**Re: Pensacola Hydroelectric Project, FERC Project No. 1494-461
Response to Comments on Relicensing Study Plan, Including Requested
Contaminated Sediment Transport Study**

Response to Technical Comments on July 24 Filing

Figure A1 from the City of Miami's Comments on GRDA's DLA.⁸

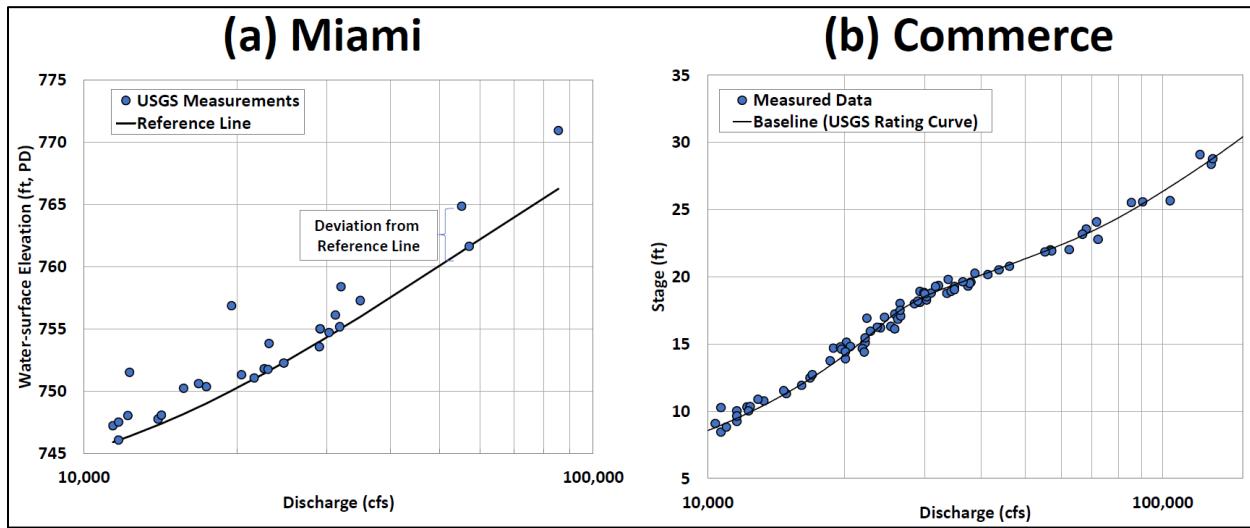
Regarding Figure A1(a), the City admits that “a line was visually-fitted to the *lower bound* of the data site for the Miami gage.”¹⁰ There is no justifiable reason to create a biased, “visually-fitted” trendline. GRDA re-created the City’s analysis and tried fitting various statistical trendlines to the publicly available USGS data used in the analysis; no statistical trendline matched the City’s “visually-fitted” trendline. In Figure A1(a) of the City’s filing, the “Reference Line” for the Miami gage is forced to fit the lower bound of USGS data, conspicuously ignoring USGS measurements that do not fit the City’s pre-determined narrative. This is most apparent in the upper right corner of the plot, where the “visually-fitted” trendline misses the USGS measurement by 5 feet. A

To show the bias in the City's analysis, GRDA created **Figure 1**, below. The figure re-creates the City's Figure A1(a) with an important addition: a mathematically defensible, unmodified trendline, which was generated using a second order polynomial equation.

Figure A2 from the City of Miami's Comments on GRDA's DLA.⁹

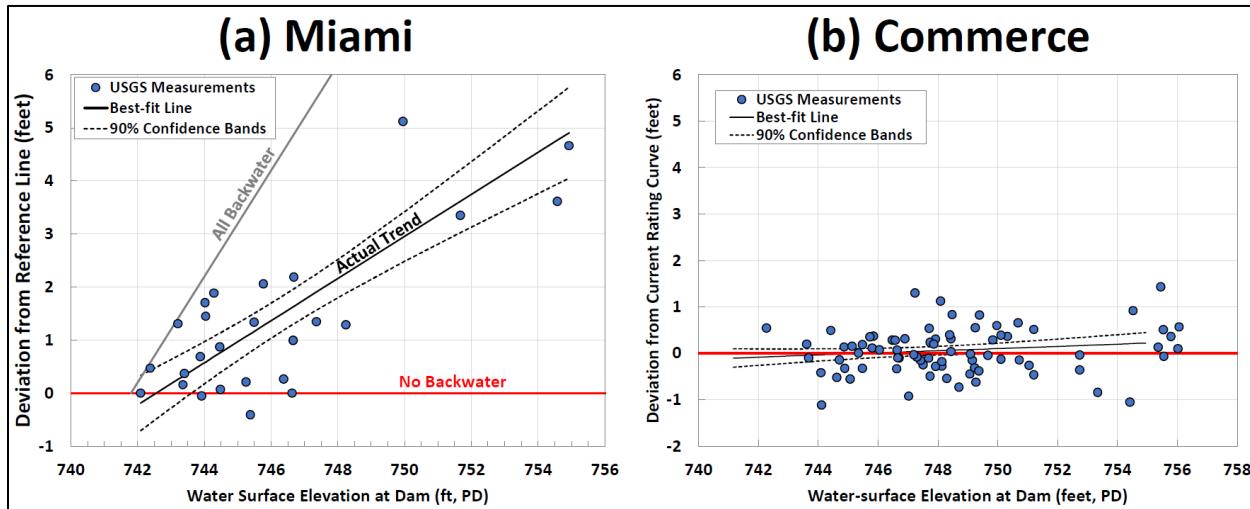
The City has already made this argument in a comment on GRDA's Draft License Application (DLA)⁵ and GRDA has already debunked the City's flawed analysis in its Final License Application (FLA).⁶ The City re-introduces its argument in part but not in whole, conveniently leaving out the most flawed underpinnings. Therefore, a detailed explanation, starting with the City's comment on the DLA, is required for a full understanding of the flawed nature of the City's argument and its mathematical indefensibility.

The City's analysis is presented in an appendix to their comments on GRDA's DLA.⁷ GRDA includes copies of the City's Figures A1 and A2 herein for the purpose of explanation. Note that each of the City's figures actually contains two plots. For example, Figure A1 contains A1(a) on the left and A1(b) on the right.

GRDA used calculated deviations from the unbiased, mathematically defensible trendline to re-create the remainder of the City's analysis at the Miami gage. The results are presented in **Figure 2** below, which re-creates the City's Figure A2(a).¹¹ After replacing the artistic, biased trendline with a mathematically defensible, second order polynomial trendline, there is no "obvious and strong trend in the Miami data" as purported by the City.¹²

Figure 1. Re-creation of the City's Figure A1(a) with additional statistical information: a mathematically defensible, unmodified trendline.

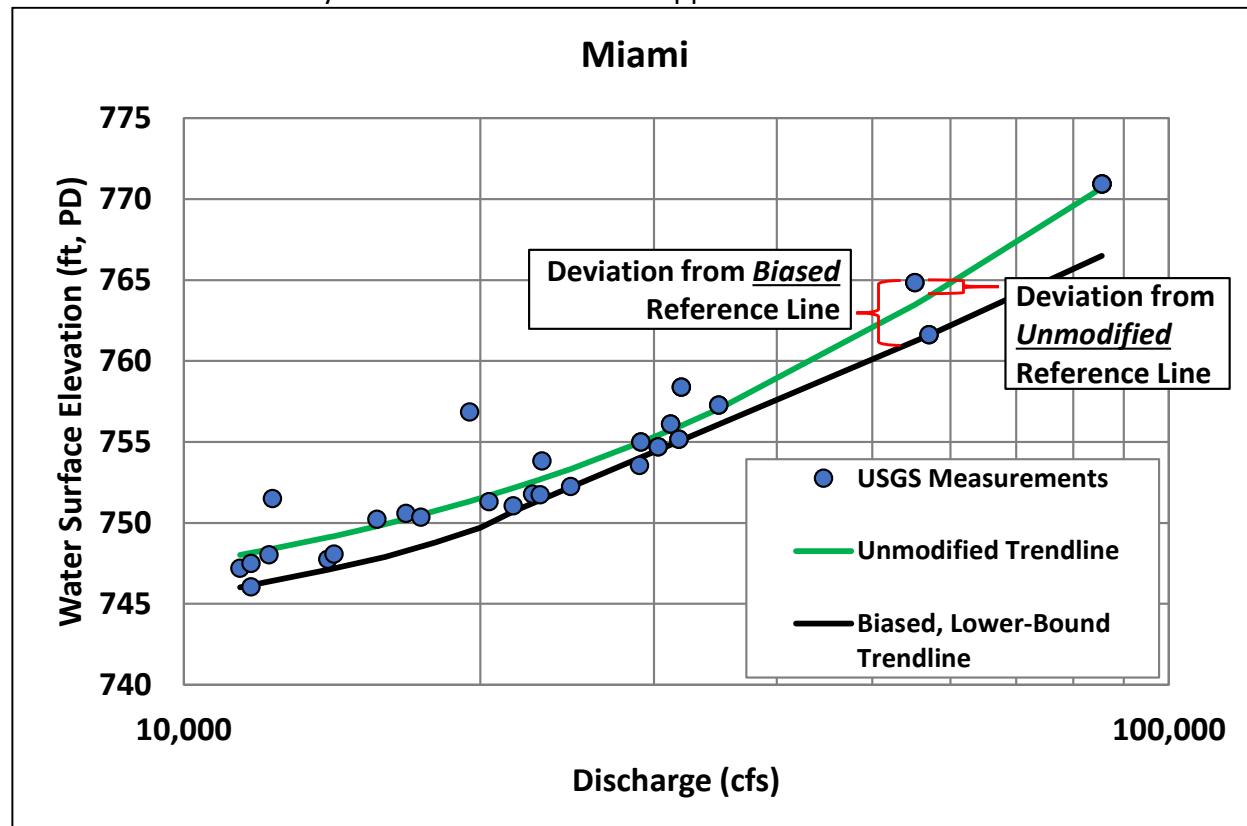
The difference between the City's biased, "visually-fitted" trendline (black line) and the unmodified trendline (green line) is striking. Not only does the comparison show how the City's biased trendline was forced through the lower bound of the data while ignoring USGS measurements at high flows and high water surface elevations, the comparison also makes the *artistic* nature of the City's biased trendline more apparent.

The annotations in **Figure 1** also re-create the City's purported "Deviation from Reference Line" example and add a real, unbiased deviation example. The real deviation is minuscule in comparison to the biased deviation.
